# UNITED STATES PATENT AND TRADEMARK OFFICE

**Advisory Action  
Before the Filing of an Appeal Brief**

10/722,590

## [54] ELECTRONIC CLINICAL THERMOMETER

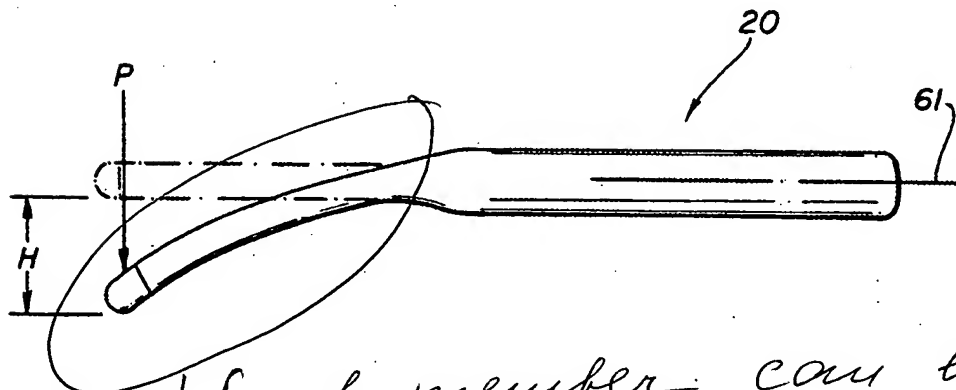
Continuation of 3. NOTE: cl. 17: "circumferential edge" introduces a new issue because this limitation is different from the previously stated limitation "along a perimeter". Normally, the term "perimeter" in geometry means the entire perimeter, therefore, "along the perimeter" would mean "along the entire perimeter". Newly presented limitation "having a circumferential edge" could be interpreted that the first member has only a small part of the perimeter which is circumferential in shape. Therefore, the newly presented limitation to claim 17 broadened the claim language and requires a new search and consideration. Perhaps applicant should describe the first member as --having a circumferential edge along a perimeter, the edge defining a margin between an upper portion and a lower portion of the first member--. Also, cls. 18-20: it is not clear how the first member described in presently amended cl. 17 is an arcuate-shaped probe. It appears that claims 17 and 18-20 describe different embodiments (shown in Figs. 4 and 3 respectively). Also, perhaps applicant should show an arcuate-shaped temperature sensor (vs. arcuate-shaped probe) of claim 21. In addition, perhaps applicant should show numerals 28 and 30 described in the specification. Also, see attachments ##1-2 (Zaragoza et al. U.S. 5013161).

1 first member can be  
arcuate-shaped
